ECE/TRANS/WP.29/GRSP/46
26 January 2010

Working Party on Passive Safety

**REPORT OF THE WORKING PARTY ON PASSIVE SAFETY
ON ITS FORTY-SIXTH SESSION
(Geneva, 8 - 11 December 2009)**

Fig. 1 - Front impact test

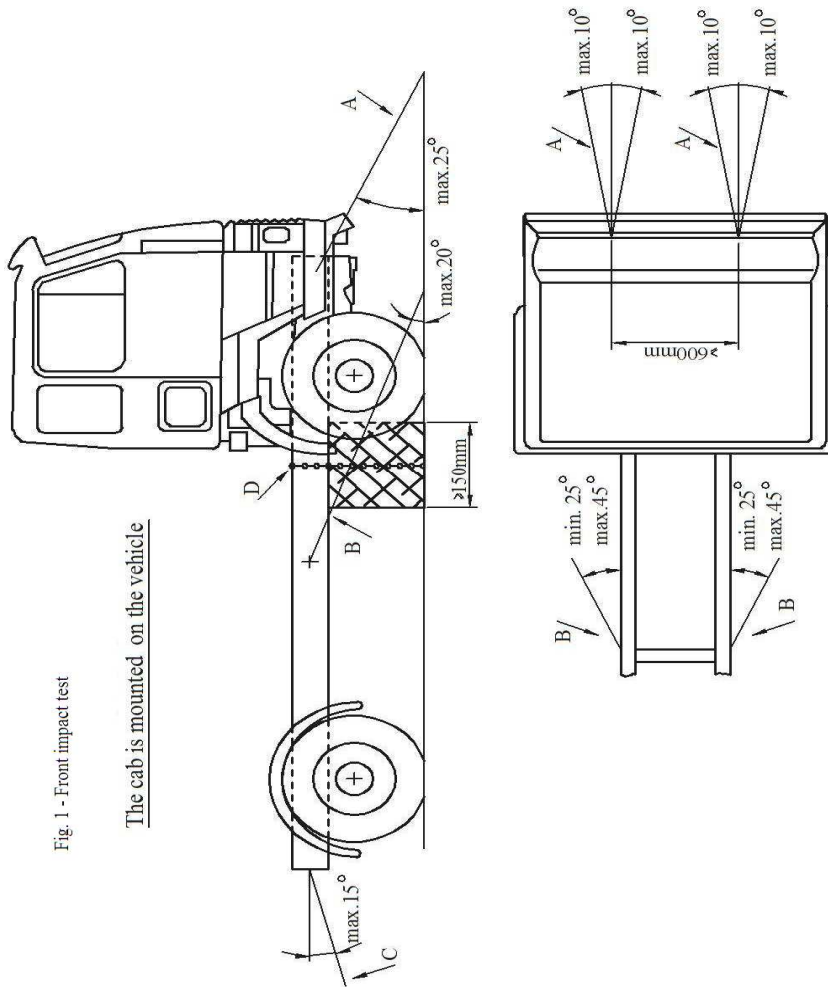
"5.1. The impactor shall be made of steel and its mass shall be evenly-distributed; its mass shall not be less than 1,500 kg. Its striking surface, rectangular and flat, shall be 2,500 mm wide and 800 mm high (see b and h on Figure 1). Its edges shall be rounded to a radius of curvature of **10 mm ± 5 mm.**"

Figure 1, amend to read:
